Item Name: Shim

ENGINEERING CHANGE NOTICE NL 04510

DWG NO. 647.4100

DWG TITLE: SHEETMETAL

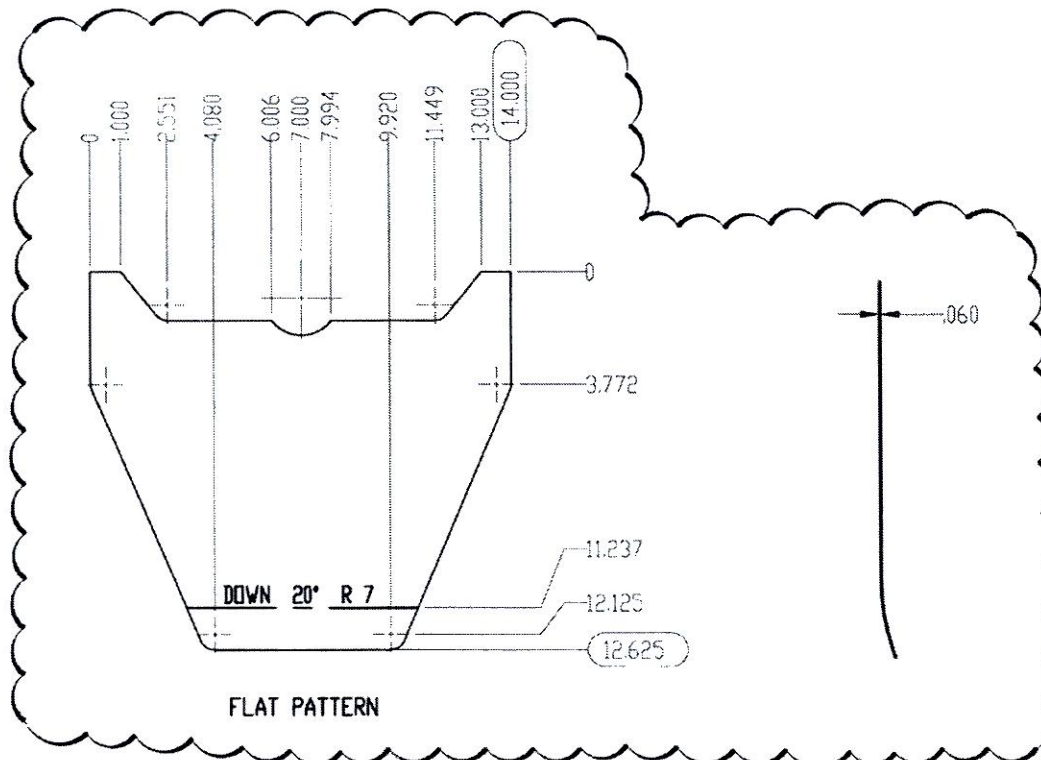
REASON: MODIFIED DOUBLER.

SHEET 1, ZONE C2 IS:

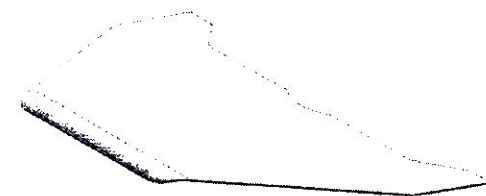
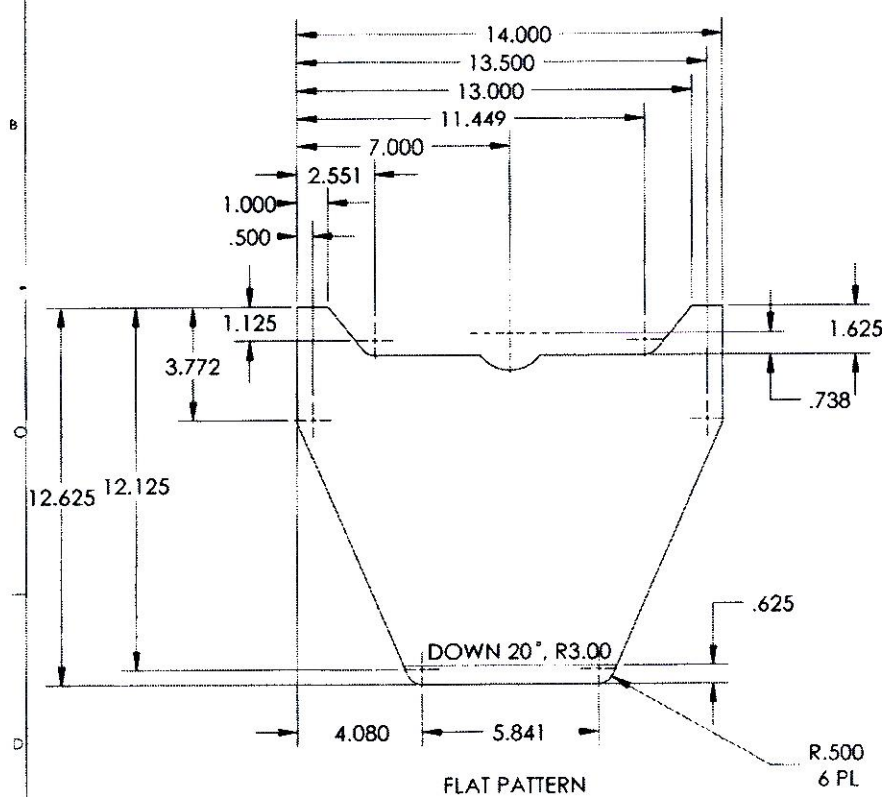
SHEET 1, ZONE A1 IS:

1. MATERIAL: ALUMINUM 2024-T3 PER AMS-QQ-A-250/4
2. FINISH: HARD ANODIZE (AW MIL-A-8625 TYPE II, CLASS 2, COLOR BLACK);
PRETREAT PR-148 ADHESION PROMOTER
PRIME (AW MIL-P-23377) TYPE I CLASS N
3. DEBURR AND BREAK ALL SHARP EDGES
4. IDENTIFY (AW MPP-120)

1. MATERIAL: ALUMINUM 2024-T3 PER AMS-QQ-A-250/4
2. FINISH: HARD ANODIZE IAW MIL-A-8625 TYPE II, CLASS 2. COLOR BLACK; CARDINAL 4860-50 PRETREATMENT PRIMER PRIME IAW MIL-P-23377 J TYPE I CLASS N
3. DEBURR AND BREAK ALL SHARP EDGES
4. IDENTIFY IAW MPP-120
